GEORGETOWN-SCOTT COUNTY PLANNING COMMISSION
AGENDA

February 12, 2015
6:00 p.m.

EVERYBODY'S AUTO SALES
Staff Report to the Georgetown-Scott County Planning Commission
February 12, 2015

Staff Report to the Georgetown-Scott County Planning Commission February 12, 2015

PRELIMINARY LANDSCAPE PLAN

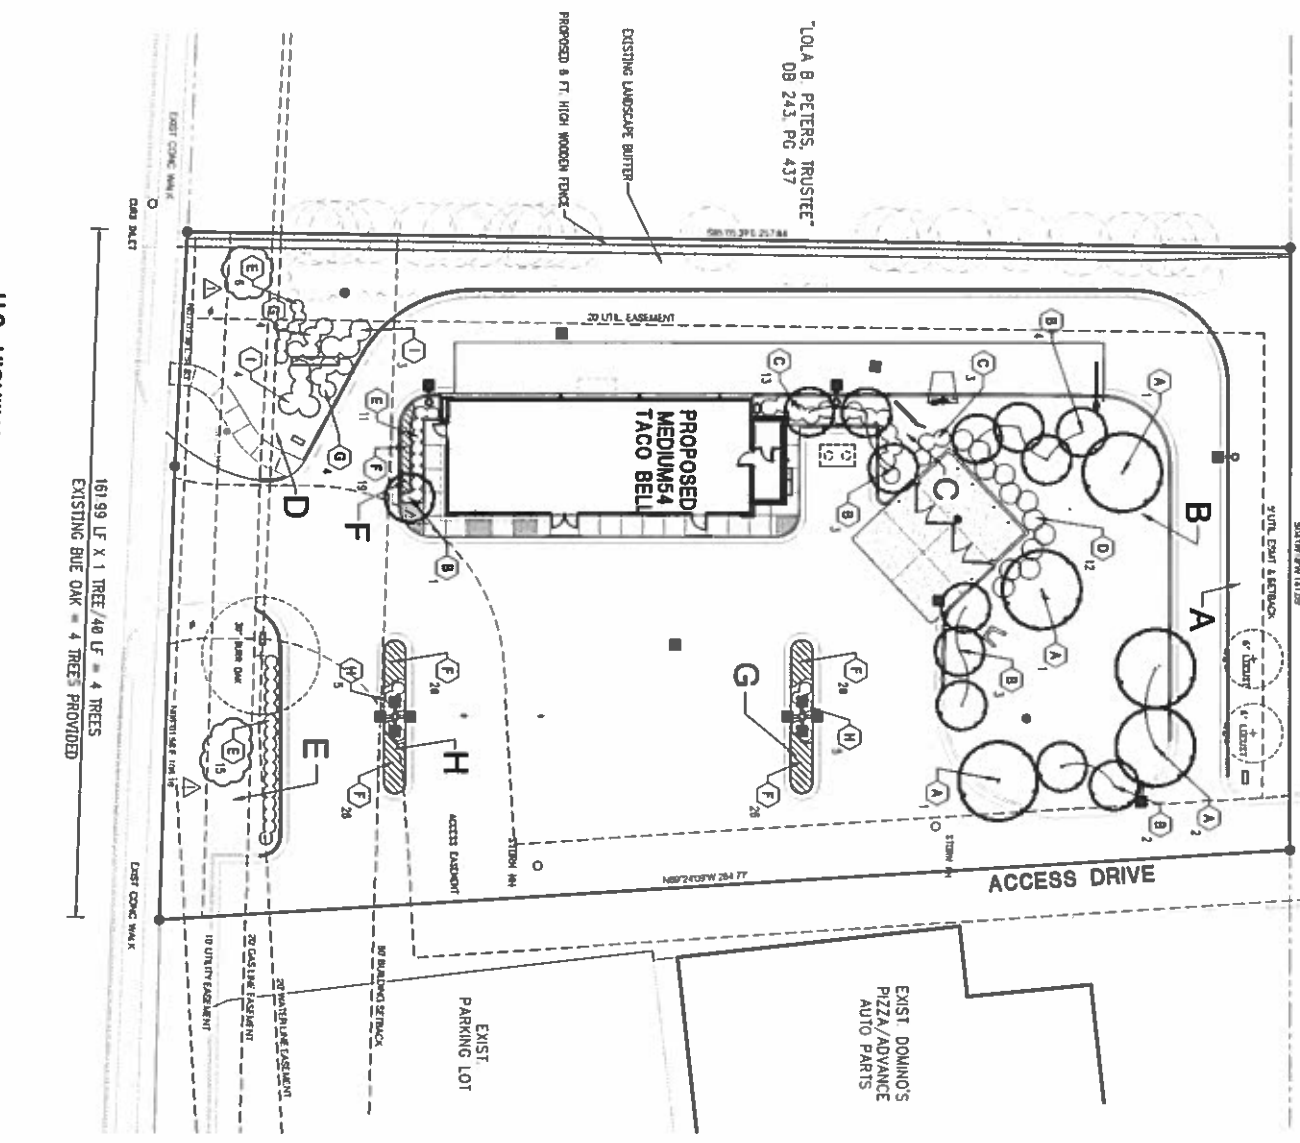
The Landscape Ordinance requires interior landscape islands equal to 10% of the vehicle use area (VUA). These islands should be planted with two (2) trees per 250 square foot of area. In addition perimeter VUA landscape should be provided at one (1) tree per 40 linear feet plus a 3 foot high hedge. The proposed Preliminary Development Plan shows adequate interior landscape islands, interior trees and perimeter VUA trees. There is also a landscape buffer required between this land use and the A-1 property to the north. This buffer is being met with existing landscaping. The site adjoins B-2 Commercial areas to the south and east, so no perimeter landscape buffers are required in these areas.

2. The Final Development Plan shall meet all the requirements of the Landscape and Land Use Buffer Ordinance.
3. A species-specific Landscape Plan shall be submitted along with the Final Development Plan.
